UNITED STATES PATENT AND TRADEMARK OFFICE

APPLICATION NO.	FILING DATE	FIRST NAMED INVENTOR	ATTORNEY DOCKET NO.	CONFIRMATION NO.
10/073,370	02/05/2002	Cathleen Woodall	2858	4346

Office Action Summary

WOODALL ET AL.

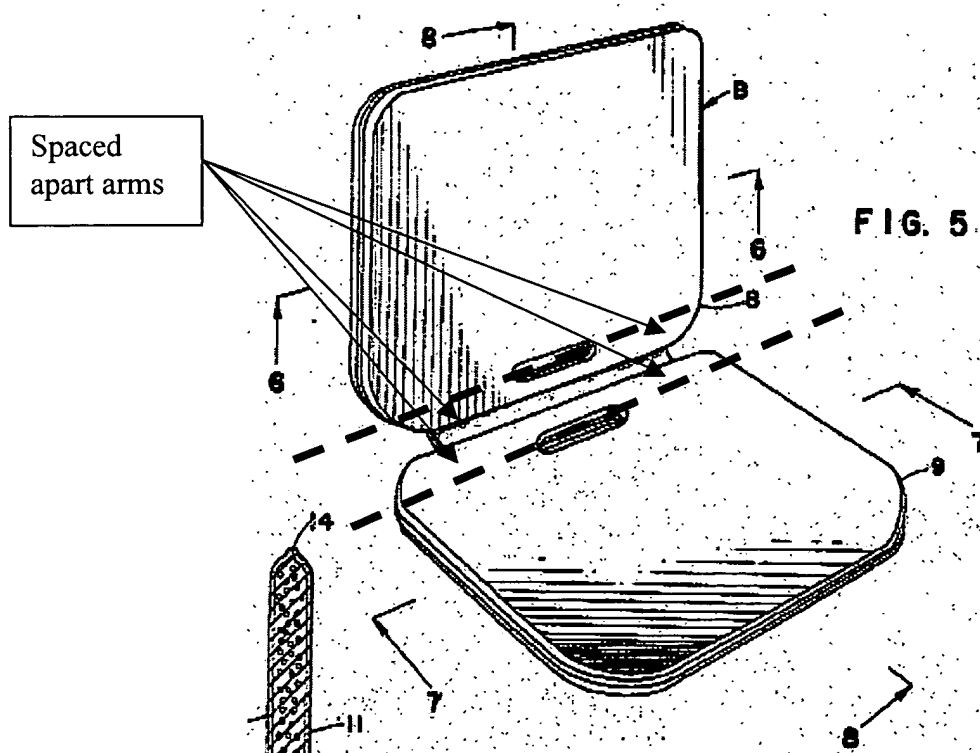
As to the Lerman reference, applicant argues (pg.10-12) that "...there are no spaced apart arms interconnecting the handgrips 21/22 and the pads 8/9. Applicant is directed to modified Figure 5 which immediately follows this paragraph. The handle consists of the holes 17/18 and the handgrips (portions directly between the holes). The spaced apart arms are directly to the left and right of holes 17/18, and interconnect the pads 8/9 with one another. In modified Figure 5, the spaced apart arms are shown. Applicant also argues that "...the handgrips 21/22 as taught by Lerman do not constitute a single hinged handle. The examiner disagrees because the part 16 is a single hinged handle.
